UNITED STATES NUCLEAR REGULATORY COMMISSION

WATTS BAR NUCLEAR PLANT, UNIT 1 - ISSUANCE OF AMENDMENT TO

TECHNICAL SPECIFICATION 4.3.1 CRITICALITY (TAC NO. MF2515)

Amendment No. 95 License No. NPF-90

FIGURE 4.3-3
MINIMUM REQUIRED BURNUP FOR UNRESTRICTED STORAGE
OF FUEL OF VARIOUS INITIAL ENRICHMENTS

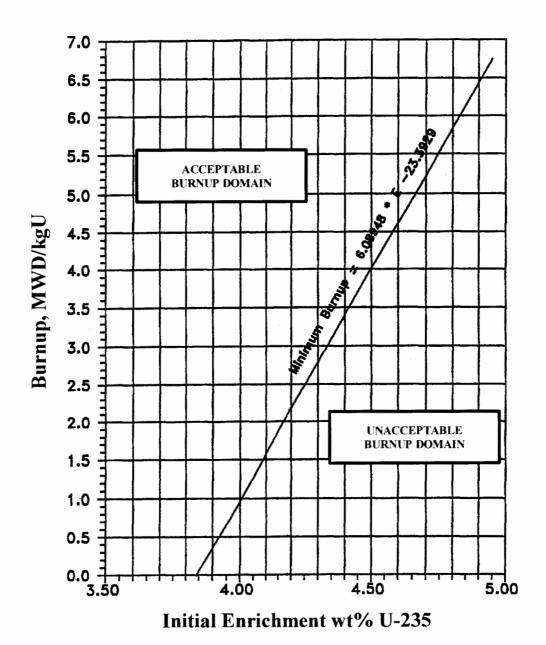
TVA proposes to revise WBN Unit 1 TS to remove the allowance of fuel assemblies with enrichments less than or equal to 3.80 weight percent U-235 be stored without restriction. Currently, all acceptable and unacceptable storage regions in terms of burnup versus initial U-235 enrichment conditions are defined by burnup curve figures in the TS Figure 4.3-3 for non-checkerboard configurations and Figure 4.3-4 for checkerboard configurations. Figure 4.3-3 includes a zero burnup storage limit at approximately 3.84 weight percent U-235. In the proposed revised TS, the existing TS 4.3.1.1.d would be deleted, and TS 4.3.1.1.e would be renumbered and revised to clarify that meeting "any" one of the four described storage arrangements satisfies the TS requirement for new and spent fuel. The NRC staff determined that the removal of previous TS 4.3.1.1.d as proposed would resolve the inconsistency between the allowance for unrestricted storage provided in TS 4.3.1.1.d and the restrictive arrangement described in TS 4.3.1.1.e.2, which includes TS Figure 4.3-4 for storage of new and spent fuel assemblies in the spent fuel racks. The proposed change would also modify current TS 4.3.1.1.e.1 and the title of TS Figure 4.3-3 to clarify that both are applicable to all fuel assemblies and not only spent fuel assemblies. These changes are consistent with the existing criticality safety analysis and the burnup curve in Figure 4.3-3, which has a zero burnup value applicable to new fuel.

Based on the above evaluation, the NRC staff has concluded that the proposed TS changes to remove the inconsistencies and clarify existing requirements in TS 4.3.1.1 and Figures 4.3-3 and 4.3-4, are editorial in nature, thus, the proposed changes are acceptable.

- Fuel assemblies may be stored in the racks in an all cell arrangement provided the burnup of each assembly is in the acceptable domain identified in Figure 4.3-3, depending upon the specified initial enrichment.

FIGURE 4.3-4
MINIMUM REQUIRED BURNUP FOR A CHECKERBOARD ARRANGEMENT OF 2 SPENT AND 2
NEW FUEL ASSEMBLIES OF 5wt% U-235 ENRICHMENT (MAXIMUM)

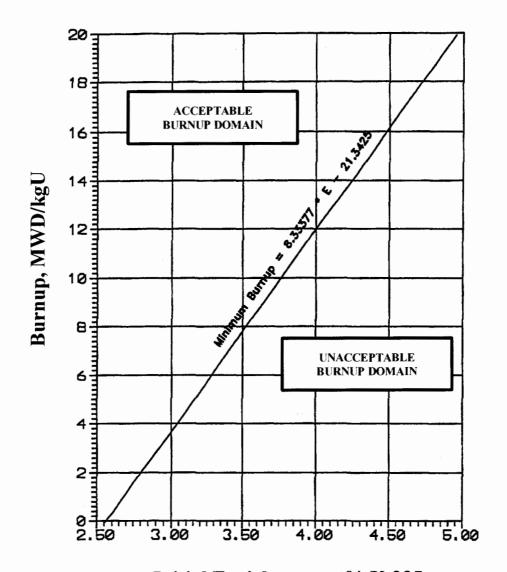
The title of Figure 4.3-4 is also revised to indicate it applies to assemblies stored in a checkerboard arrangement of two spent and two new fuel assemblies to be consistent with the language in current TS 4.3.1.1.e.2. Also, the weight percent abbreviation (wt%) and U-235 are added in the title for clarification purposes.

- 2. New and spent fuel assemblies may be stored in a checkerboard arrangement of 2 new and 2 spent assemblies, provided that each spent fuel assembly has accumulated a minimum burnup in the acceptable domain identified in Figure 4.3-4.
